Re: Albuquerque Healthcare for the Homeless

1220 First Street NW

Request Permanent C.O. - Accepted

Sheet AS-001, revised and dated 11-17-2014 (2 copies)

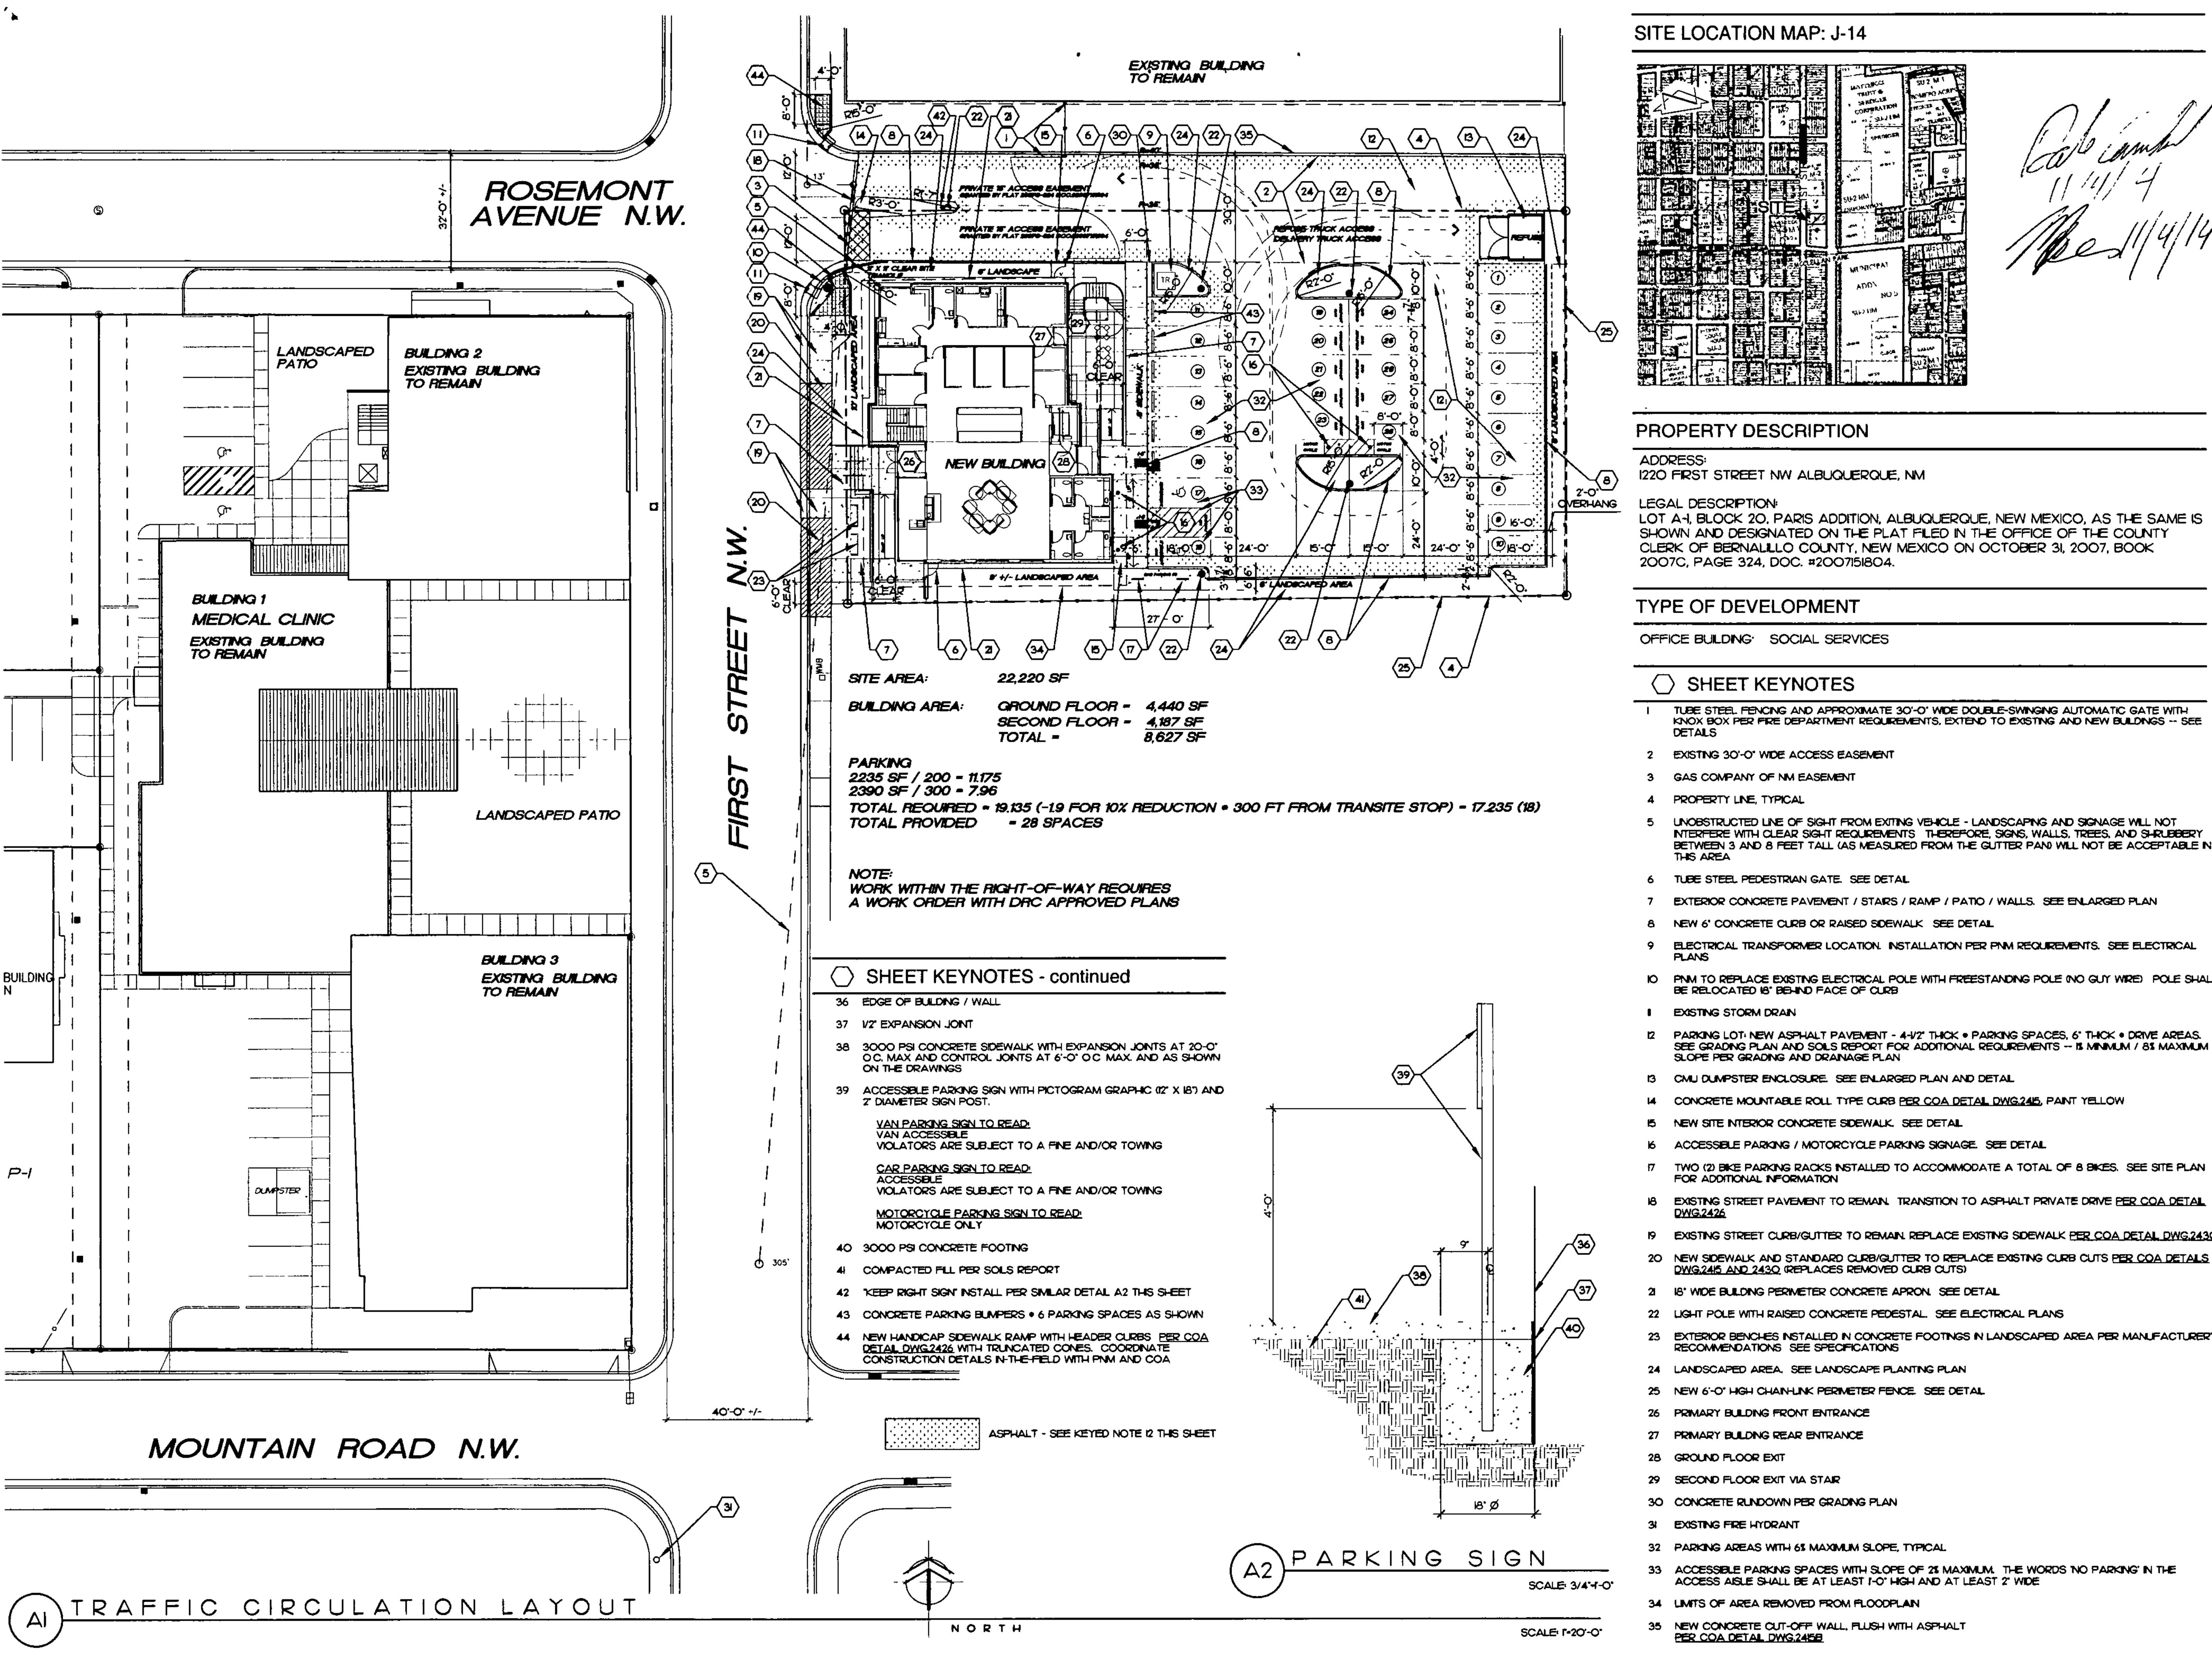
- 1. After reviewing the provided plat, there still needs to be some verification that the property owner to the north is in approval of the construction within his property. You may achieve this by having him sign a letter that he approves the paving improvements shown on the latest and greatest site plan or by having him give his signature on a copy of the latest site plan.

- 2. The wheelchair ramps across the 30-foot access easement look good in concept along with some of the dimensions that were added. However, the City of Albuquerque is unable to approve the site plan showing that the remaining construction details can be worked out in the field. Show the remaining details including remaining wheelchair ramp and truncated dome area dimensions, proposed easement dimensions, required slopes, and dimensioning and call-out of header curb. (The proposed spot elevations look like they will work to provide the required 2% cross-slope across the 30-foot access easement. Proceed to call out the 2% maximum cross-slope across the 30-foot easement.) Provide this detail within the set of plans.

Based on your letter dated 10-30-2014, please find the enclosed revisions to the Traffic Circulation Layout originally submitted on 10-10-2014, as well as the following responses to address your comments:

- 1. A letter and Site Plan signed by the adjacent Owner acknowledging the development of the access easement were uploaded to ePlan.
- 2. Wheelchair ramps have been detailed on the Traffic Circulation Layout and uploaded to ePlan.
- 3. The Owner will coordinate with Jane Rael regarding an easement for the South wheelchair ramp.

Sheet AS-001, revised and dated 10-23-2014 (2 copies)

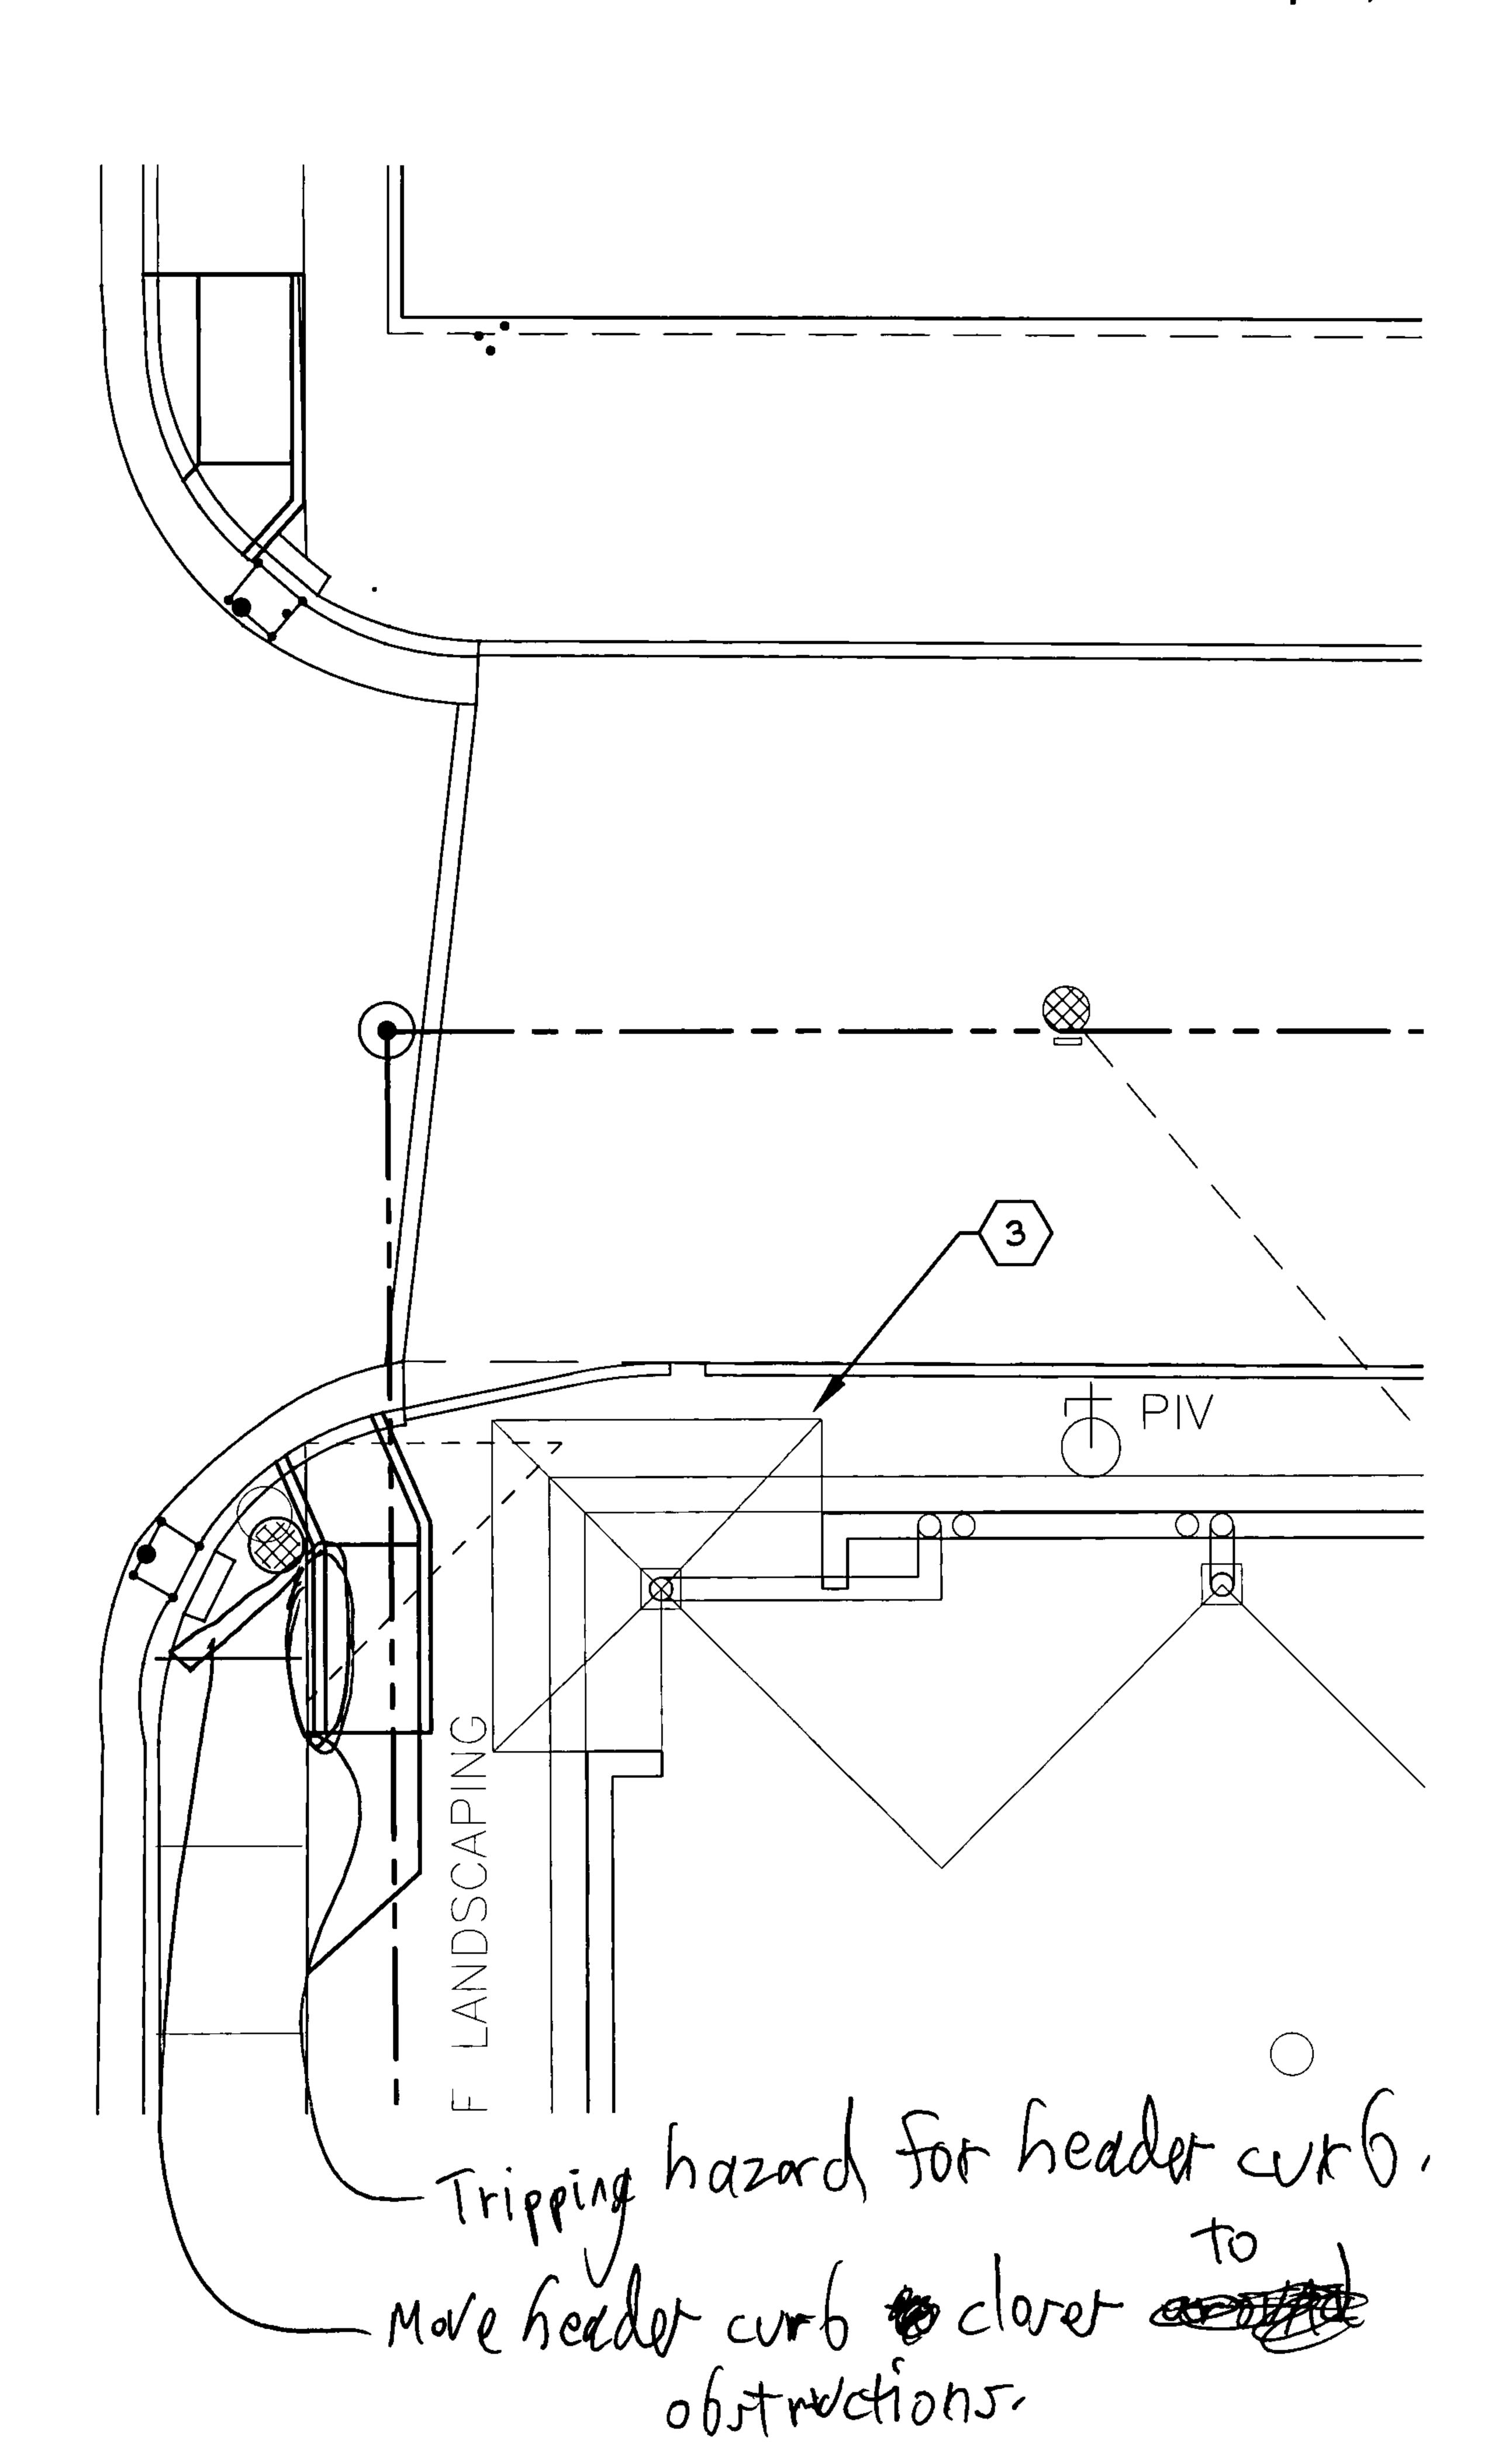
1. The total required number of parking spaces is listed as 18, but a total number of 28 is provided. Please clarify.

- Identify the existing street widths for Rosemont Avenue and First Street. Label the 15-foot access easements as "Private 15-foot Access Easements".
- 3. The handicap accessible spaces must be a minimum of 8.5 feet in width. One is shown as only 8.0 feet wide.

4. The parking spaces on the east side of the lot are shown as 16 feet wide, and they need to be a minimum of 18 feet wide.

- 5. Provide signage detail as called out by Keyed Note 16 on the plan. The ADA van accessible sign must have the required language per 66-7-352.4C NMSA 1978 "Violators Are Subject to a Fine and/or Towing."
- 6. The words "NO PARKING" in the ADA access aisle shall be at least one foot high and at least two inches wide (66-1-4.1.B NMSA 1978). Designate this on the drawing.
- 7. List radii for all curb radii on entrance to access easements from First Street.

Also, include curb radii information for the median. Wheelchair ramps must be provided for wheelchair access across the 30-foot access easement along with truncated domes. Show lane widths from the median curb to the outer curb.
- 8. The new PNM Pole called out on Keyed Note 10 needs to be a minimum of 18 inches behind the face of curb.

- 9. Provide a "Keep Right" sign on the median for traffic entering the access easement from First Street. Paint the median curb yellow.
- 10. A 6 foot-wide ADA accessible pedestrian pathway is required from the public sidewalk on First Street to the building entrances. Please widen the ramp up to the primary building front entrance to 6 feet wide.

- 12. Provide a 6-inch or 8-inch high concrete barrier curb between the parking lot and the 8-foot sidewalk on the east side of the new building.
- 13. The design delivery vehicle route needs to be shown.

- 14. It is not apparent what type of pavement surface is being proposed. A hard driving surface will be required as part of this proposed project for parking area and drive aisles. Show and label thickness of asphalt if providing an asphalt parking lot.

- 15. Please add the following note to the clear sight triangle: "Landscaping and signage will not interfere with clear sight requirements. Therefore, signs, walls, trees, and shrubbery between 3 and 8 feet tall (as measured from the gutter pan) will not be acceptable in this area."

- 17. Work within the public right of way requires a work order with DRC approved plans.
- 18. Please include two copies of the traffic circulation layout at the next submittal.

- 1. The Owner is trying to provide additional off-street parking to alleviate the congestion of on-street parking in the area. Some staff members from AHCH located across the street will use this parking lot.

- 2. Street widths are shown on the original drawing. The Rosemont dimension is located near the street label and the First Street dimension is located at the intersection of First and Mountain. The easement has been labeled as "Private 15-foot Access easement".

- 3. Handicapped spaces have been revised.
- 4. Parking spaces are 18' deep with 2' overhang. This is clarified on the revised drawing.
- 5. Detail was originally provided on sheet SITE501, and has been added to SITE000 (AS-001).

- 6. "No Parking" text size has been added to Keyed Note #33.
- 7. Radii at curb entrance, wheelchair ramps, and lane widths have been indicated on the revised drawing.

- 8. New PNM pole will be relocated 18" behind face of curb as shown on revised drawing.
- 9. "Keep Right" sign and yellow paint have been added to keyed Note #14.

- 10. Ramp has been widened to 6'-0' clear.
- 11. Ramp has been widened to 6'-0" clear.
- 12. 6" curbs were originally identified by elevation changes. Keyed Note #8 has been modified to also include this information.

- 13. Delivery route has been identified.
- 14. Keyed Note #12 originally indicated asphalt. This note has been modified to clarify the thickness.
- 15. Keyed Note #5 has been modified to include additional clarification regarding the clear sight triangle.

- 16. Easement was Granted by PLAT 2007C-324 (Doc.#2007151804) and this has been uploaded to the Documents Folder on the City Electronic Transmission site.

- 17. Per your previous e-mail, no DRC approval is required.
- 18. Two copies of revised drawing are included.
